**AGENDA OF THE PLANNING BOARD**

**July 1, 2021**

**10 Market Street (Grid #6158-14-300255) – JSK Rentals LLC (Jeffrey Knipe) (Owner and Applicant), Michael Gillespie of M. Gillespie & Associates Consulting Engineering P.L.L.C. (Engineer) – Reconstruction.**

Re: 2695 West Main Street  
Mixed Use Building  
Site Plan

PROPOSED GROUND LEVEL FLOOR PLAN (future commercial)

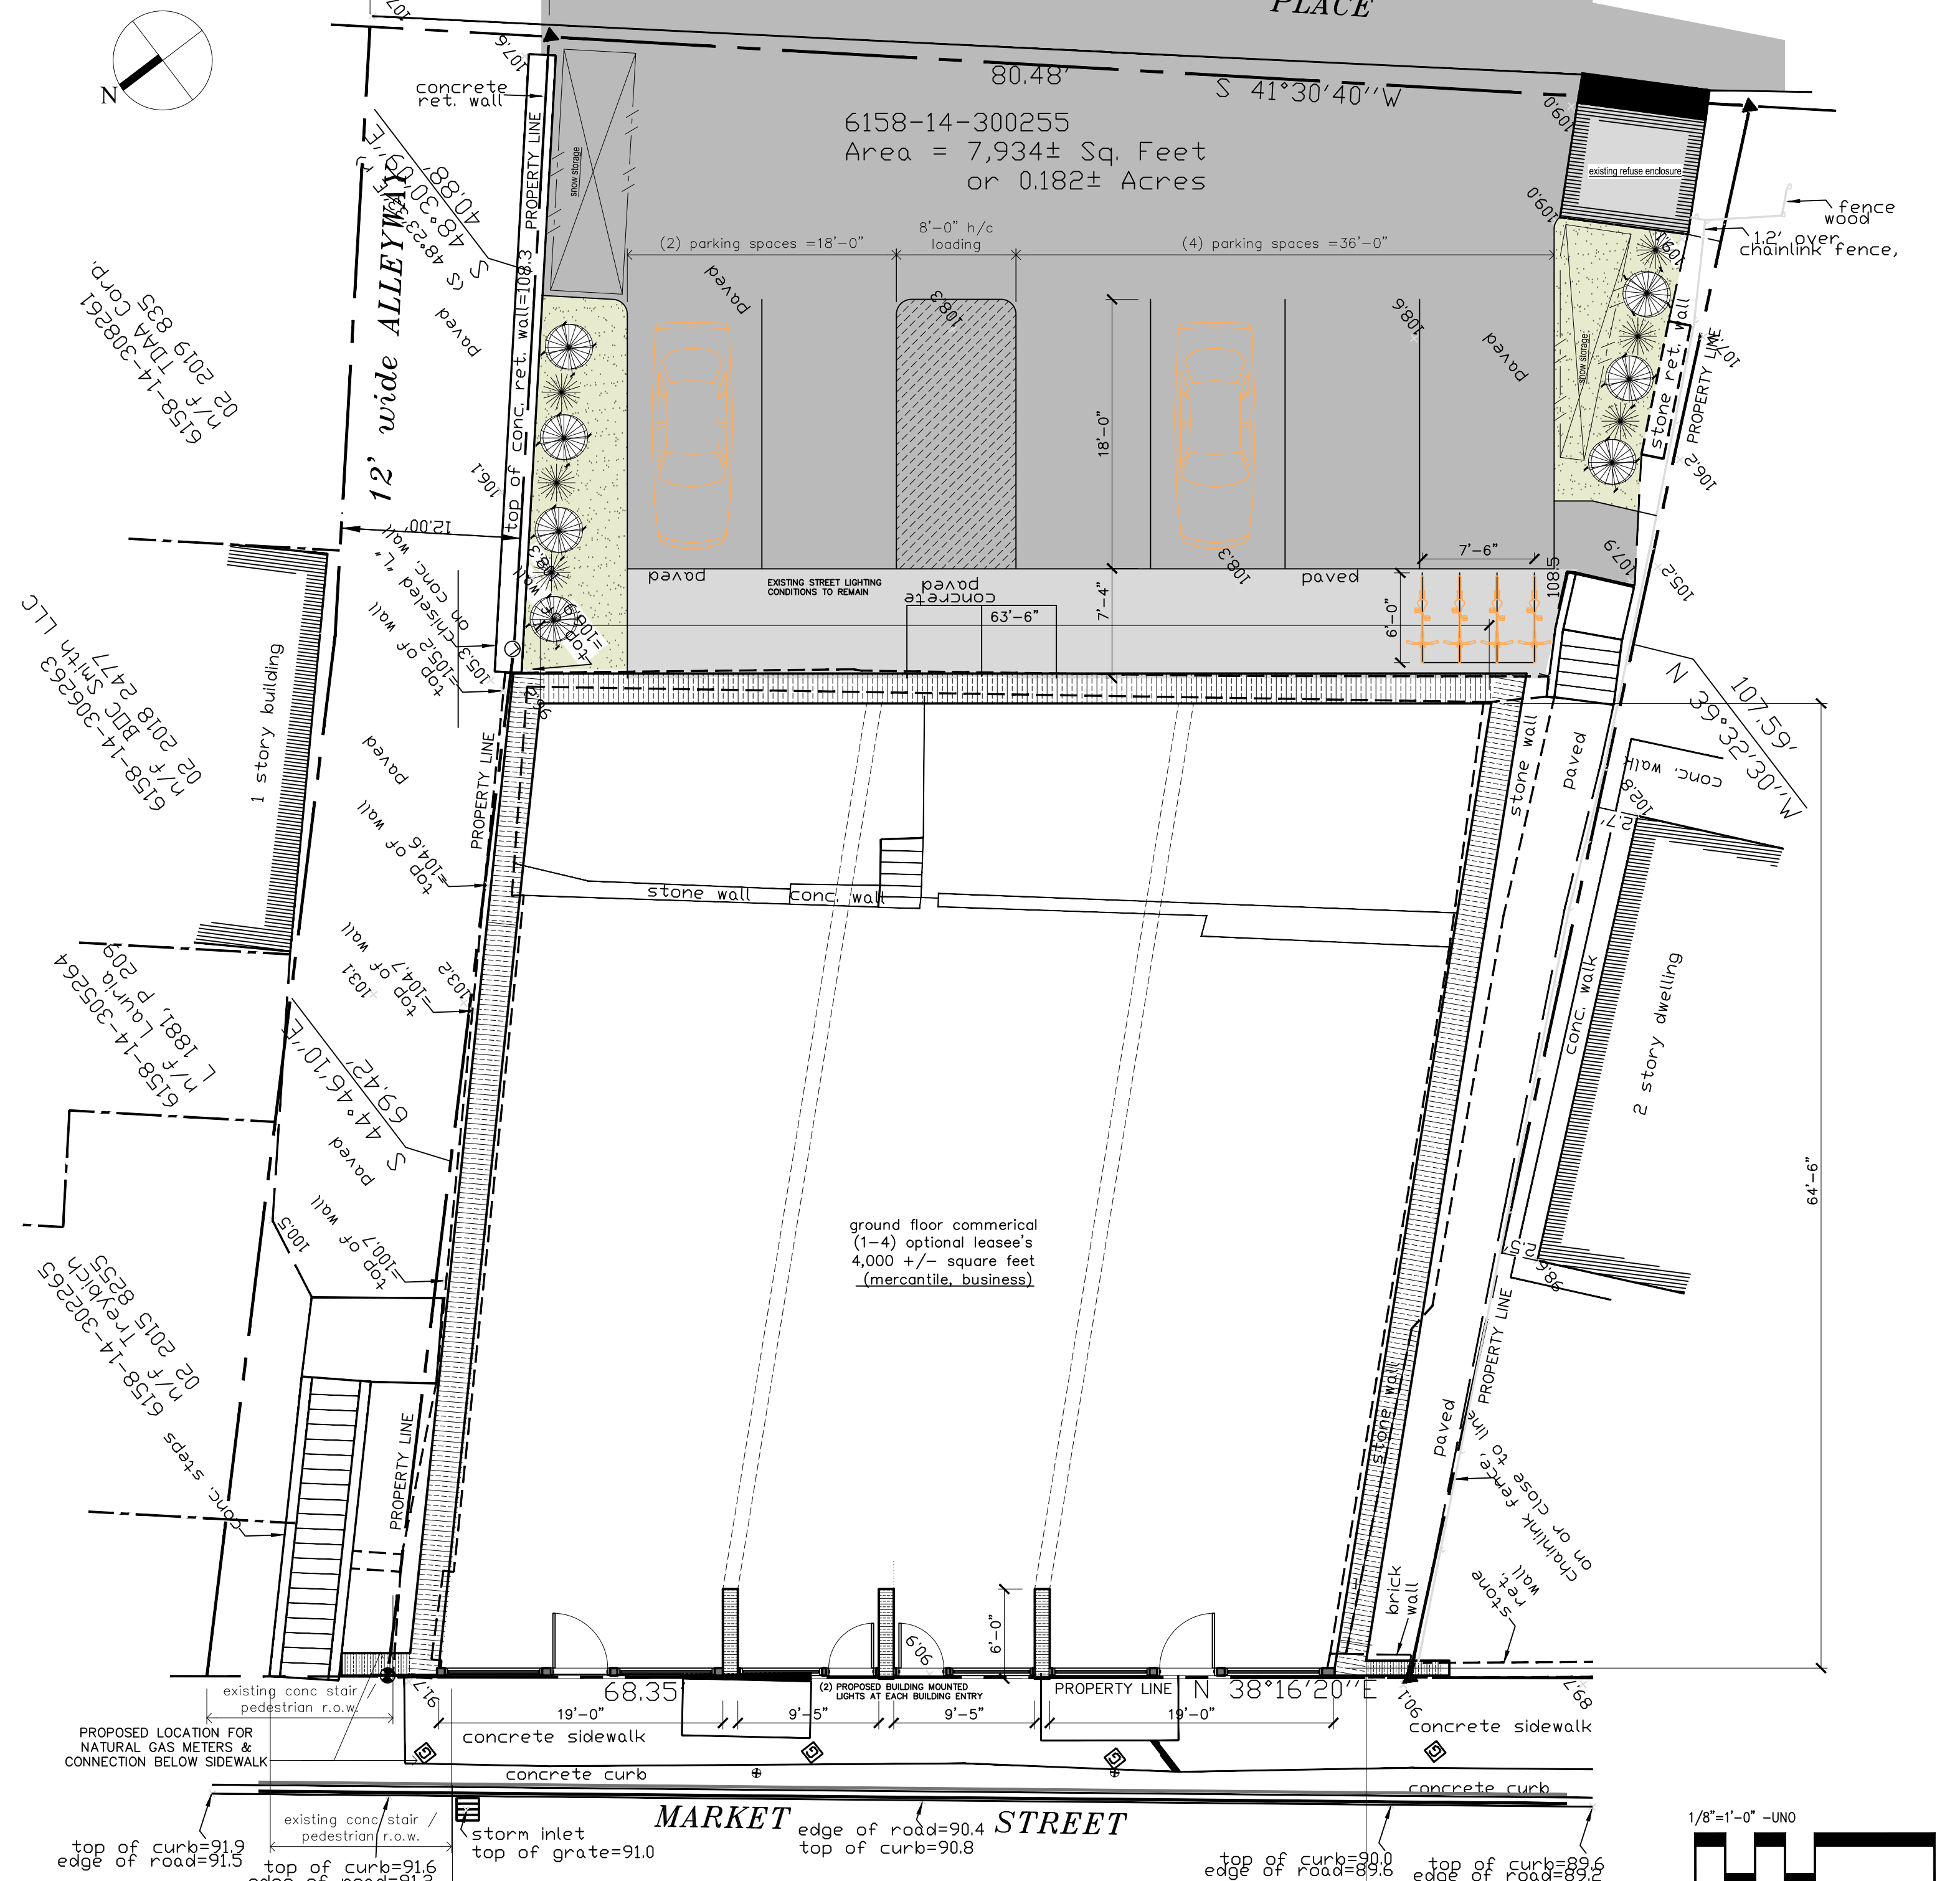
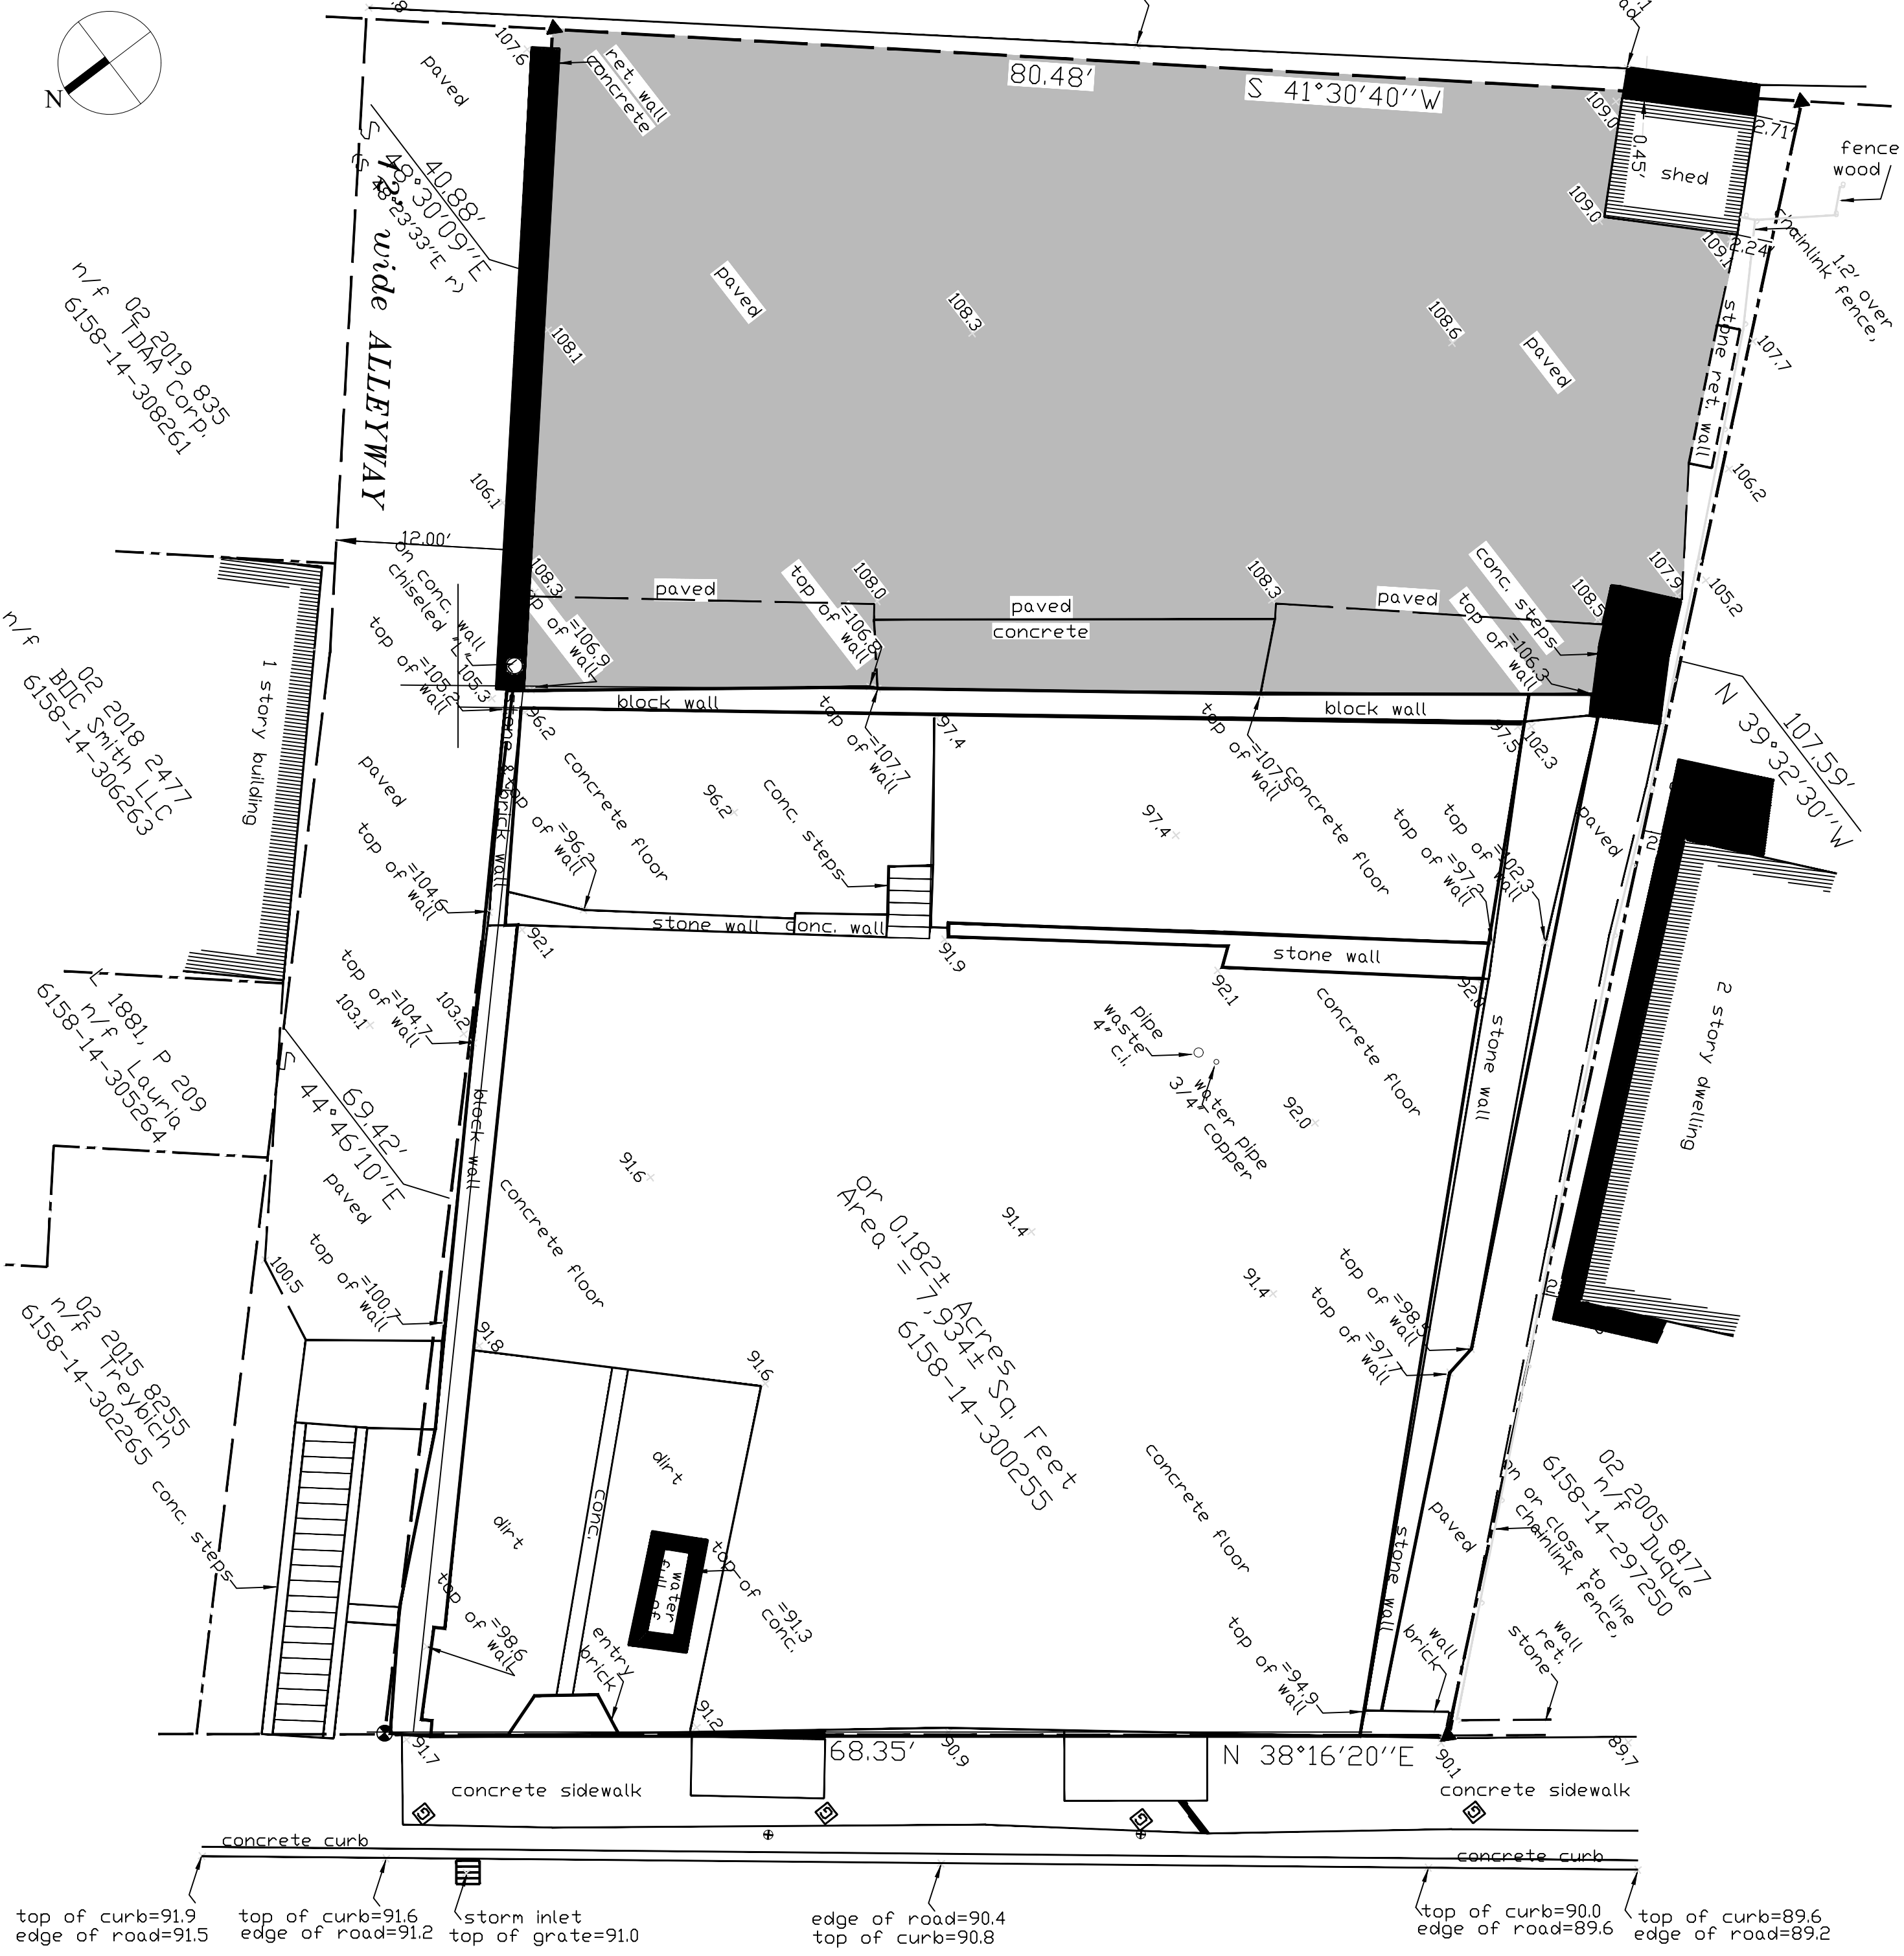
3. The "Existing and Proposed Site Plan" is to be separated into one existing conditions plan and one proposed conditions for clarity.

4. The property boundary is to be shown on the "Ground Level Floor Plan." (Sheet 1 of 4).

5. "Ground Level Floor Plan" shows what appears to be a one foot gap between the north face of the new building and the Village walkway. Also along the southerly building line and the walkway there appears to be a 30 inch gap. These gaps would pose a hazard and cannot remain. Plans are to be revised to address this.

**Response:** Existing Conditions Site Plan and Proposed Ground Level Floor Site Plan are shown separately on Sheet 1 of 4.

**Response:** Property boundary shown on Existing & Proposed Site Plans on Sheet 1 of 4.

**Response:** Gaps between the new face of the building and the existing conditions will be addressed prior to construction as Applicant and the Village coordinate.

PROPOSED (MARKET STREET) WEST ELEVATION

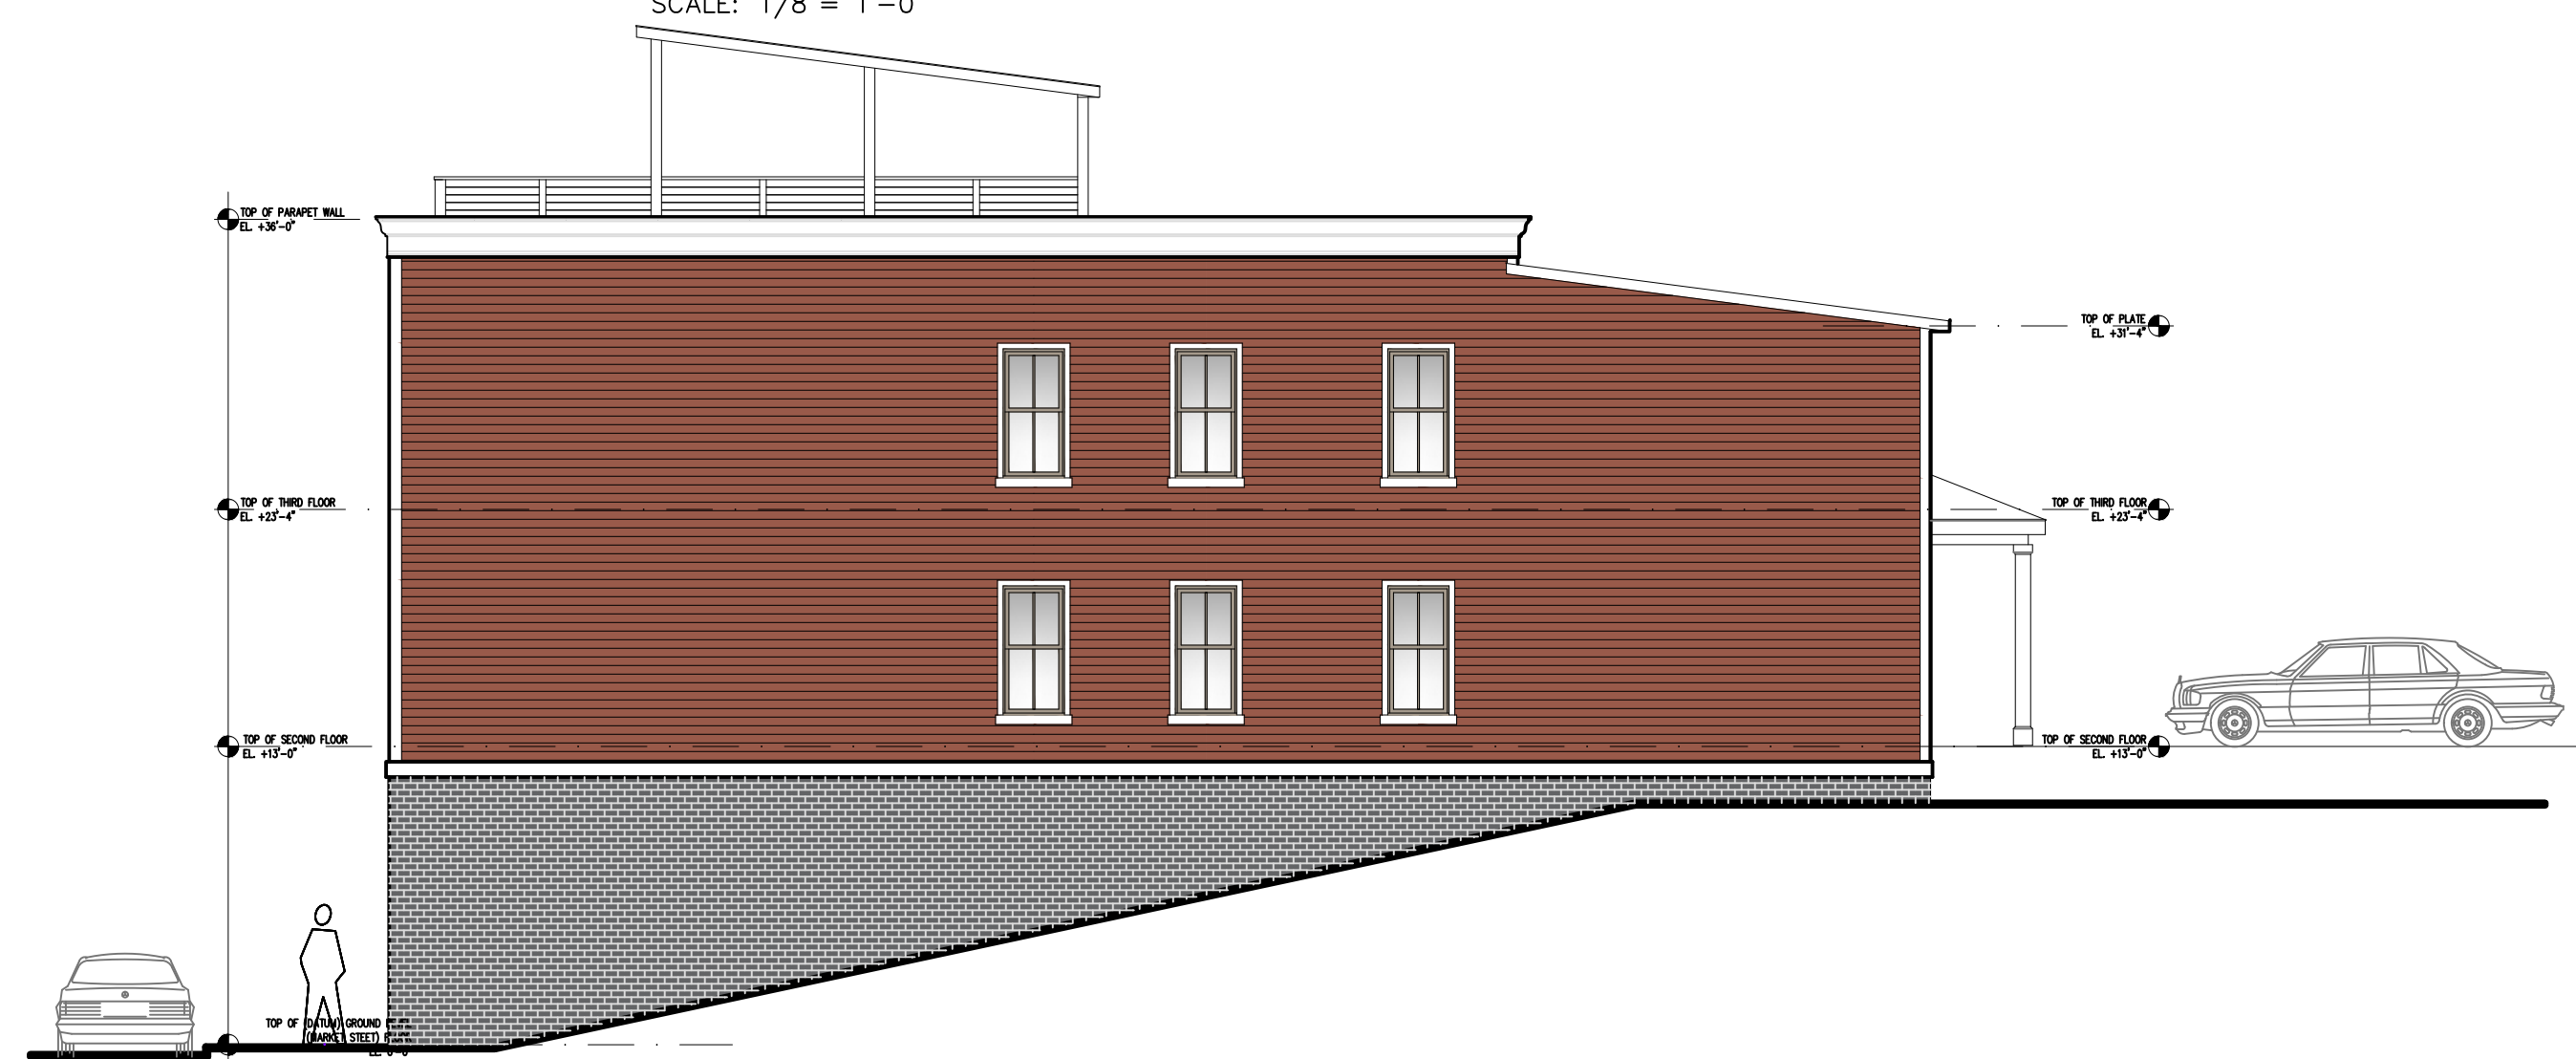
- a. The building elevations indicate that signs would be located in an area on the wall above the first-floor windows. The plans should indicate the allowable size of the wall signs; otherwise, the applicant would need to apply later for an amended site plan approval for signs.

- b. The building elevations show an area designated for signs above the second story windows. Since the uses on this floor are residential, this appears to be an error.

- 3. Signage:** The building elevations indicate that signs would be located above the first-floor windows, however no sign details were provided. We recommend that any signs be simple and clear in communicating the business name(s). The building elevations also show an area designated for signs above the second story windows. Since the uses on this floor are residential, no signs should be located here.

**Response:** Allowable size of wall signs shown on Proposed (Market Street) West Elevation on Sheet 3 of 4.

**Response:** Area designated for signs is on the first story, as shown on Proposed (Market Street) West Elevation on Sheet 3 of 4.

**Response:** Allowable size of wall signs and location above the first-floor windows is shown on updated Proposed (Market Street) West Elevation on Sheet 3 of 4.
